CONSERVATION TEAM CONSULTATION APPLICATION RESPONSE

APPLICATION REF:	25/01420/FP
CASE OFFICER:	SK
APPLICATION SITE:	Highover Farm, Highover Way, Hitchin Hertfordshire SG4 0RQ
DESCRIPTION OF WORKS:	Change of use and external alterations to former agricultural buildings comprising grade II listed threshing barn and non-listed courtyard buildings. Partial demolition of courtyard building between proposed Units 1 and 2 to facilitate access. Single-storey rear extension to facilitate Unit 10. Subdivision and two-storey rear extension to farmhouse to form Units 11 and 12. Erection of new building for two dwellings (Units 13 and 14). Partial demolition and modify building for cycle storage to Units 2 to 8 inclusive. Erection of building to accommodate 2 car port spaces for Unit 5 and refuse storage for Units 2-8 inclusive. Detached bin enclosure / cycle store buildings for Units 9 - 14 inclusive. Hard and soft landscaping in association with the provision of private and communal space. Boundary treatment, installation of 14no. EV charging points, installation of solar PV array on south facing roof slopes of Unit 14 and both the cycle and refuse storage buildings serving Units 2 -8 includ

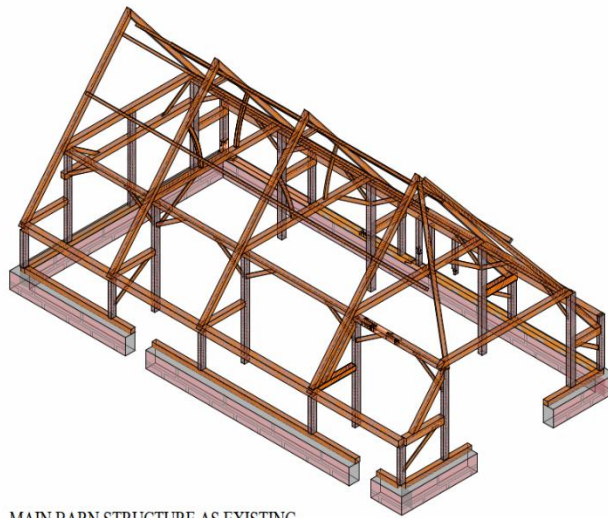
I previously said that I was not anticipating a pair of side-hung casement windows in the side elevation of Unit 2 facing onto the vehicular access to the courtyard, however, I note the applicant's response on 11 September 2025 that this window is a means of escape from bedroom 1 and that a single flush casement window wouldn't be possible. I accept the explanation given and withdraw my concern on this point.

MAIN BARN STRUCTURE AS EXISTING

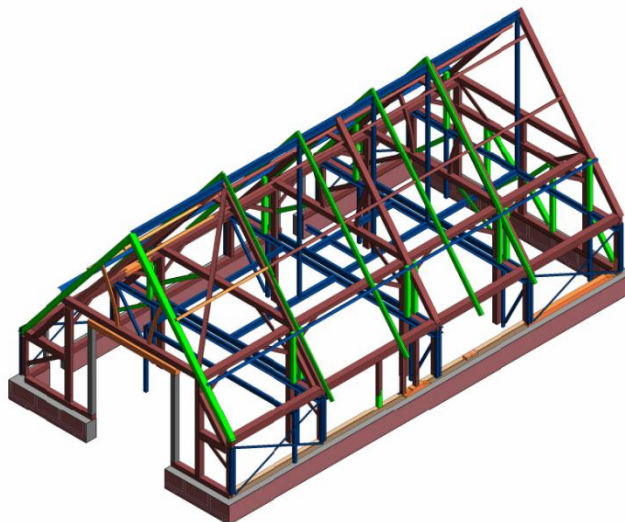
Before commenting further, I copy below extracts from drawing CE23-4293/05 prepared by AFP Consulting Engineers Ltd submitted in association with the scheme to convert a barn at Manor Farm, Kelshall. The reason for doing so is that these visuals are an incredibly helpful tool in visualising the extent of steel frame intervention in that scheme.

Typical Section

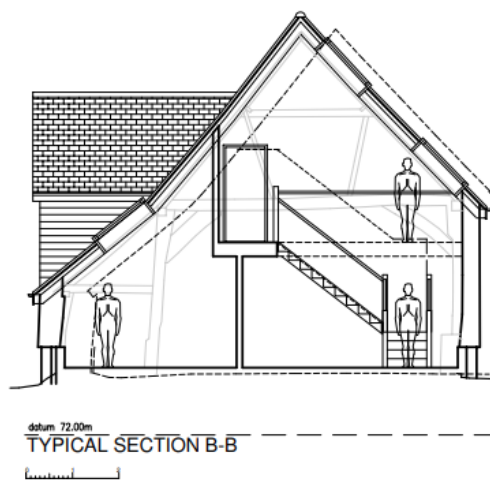
I understand the highest horizontal steels in the section drawing below will act like raised collars and that these would sit above the existing timber collar ties and would be screened by new ceilings but I feel that the character of the existing interior would be diminished if ceilings ran the length of the building concealing the timber frame in its entirety at the highest level. Where steels are not 'hidden' within walls or above ceiling finishes I would like to understand how these will appear along exposed sections of timber frame. Retaining exposed roof framing right up to the ridge is encouraged in the bedrooms and over the entrance hall void but I accept that ceilings over the bathroom and ensuite 1 would probably be acceptable. I am also slightly confused in that the roughly central column in the section drawing below does not correspond to the column position on plan i.e. is not directly under the purlin. Furthermore, it is unclear as to where this section is exactly taken from, but it would have been helpful if a section is also introduced through the new gable on Elevation 6 of drawing no. 2208.PL.08B i.e. as per Typical Section B-B below to understand how the gable projection would be formed. I would like to see this constructed in oak framing with the frame exposed internally. It is also noted that if the double lines in front of the rafters in the image below denote roof light positions, then there are no doubling-up of roof lights on Elevation 6.

It is noted that the typical section above does not completely correspond to the building's form in Typical Section B-B below – they subtly different.

4. Details of any steelwork interventions to the barn forming Unit 2 shall be submitted to and approved in writing by the Local Planning Authority prior to the commencement of any steel work. Thereafter the steel work shall be undertaken in accordance with the approved details.
